# IRC — Mechanical

2015 GROUP A PUBLIC COMMENT AGENDA

SEPTEMBER 30 – OCTOBER 5, 2015  
LONG BEACH CONVENTION CENTER  
LONG BEACH, CA

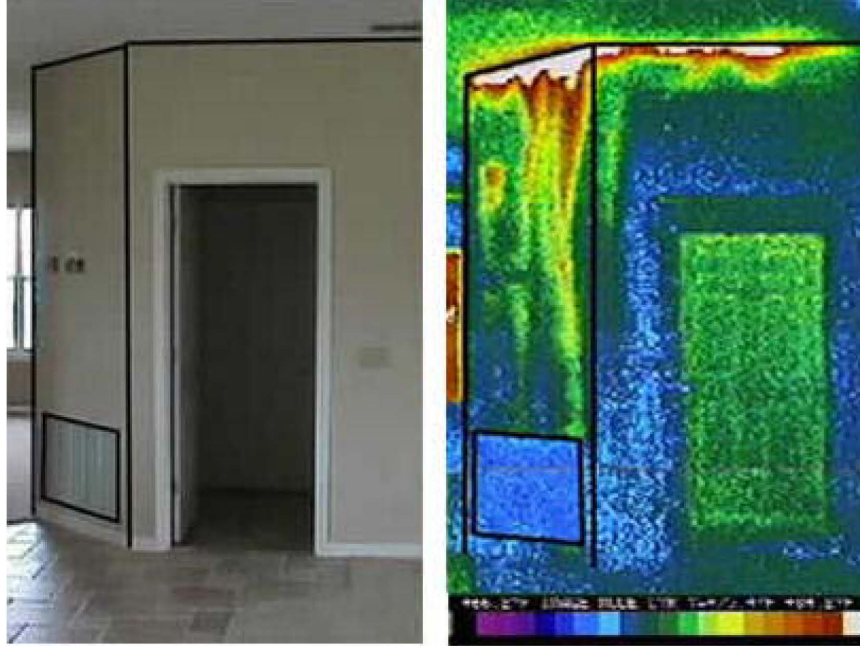
**Commenter's Reason:** The ROCAH indicates that this code change was disapproved because it was the opinion of the committee that floor joist plenums should be allowed to convey return air. Plenums/building cavities should be allowed to convey return air only if the return air is being conveyed inside of a hard duct which is located within the plenum or building cavity.

Right now there is a conflict between codes as the IECC clearly says in section R403.3.5 Building Cavities (Mandatory) "Building framing cavities shall not be used as ducts or plenums.

"Besides the Building Science rationale spelled out in the original reason statement demonstrating building durability, efficiency, and life safety issues associated with pressure imbalances associated with building framing plenums being used as duct work, the current code language addressed by this proposals ensures that the intent of the code will be met."...to provide a reasonable level of safety, health, property protection and public welfare..."

Combustion safety caused by uninhibited negative pressures, building durability

Building framing cavities shall not be used as ducts or plenums

## System Effect

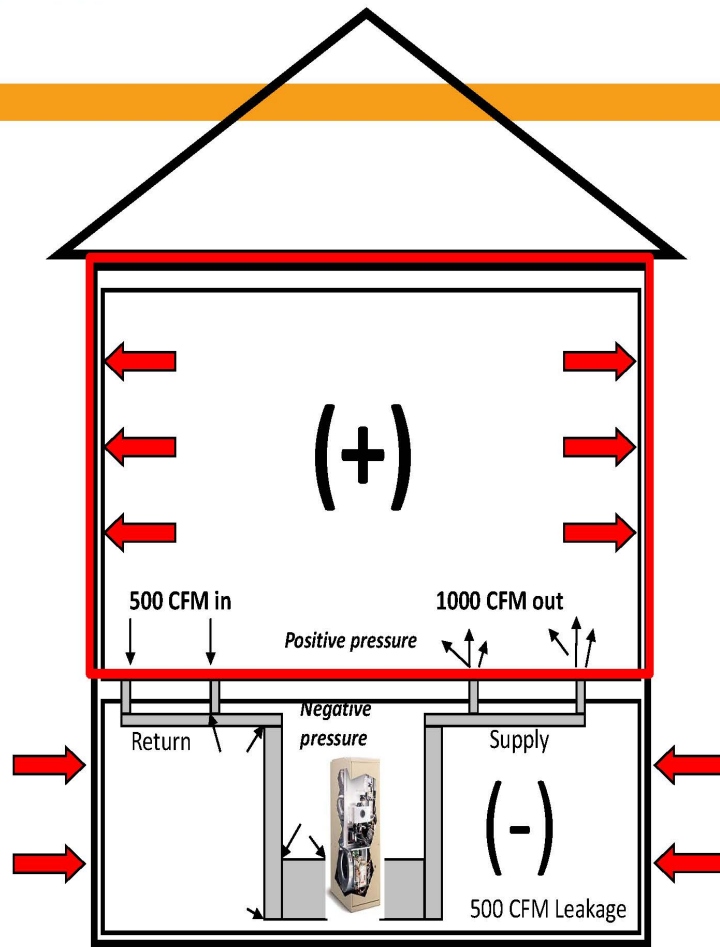
Dominant leakage on the return ducts  
Sends basement negative
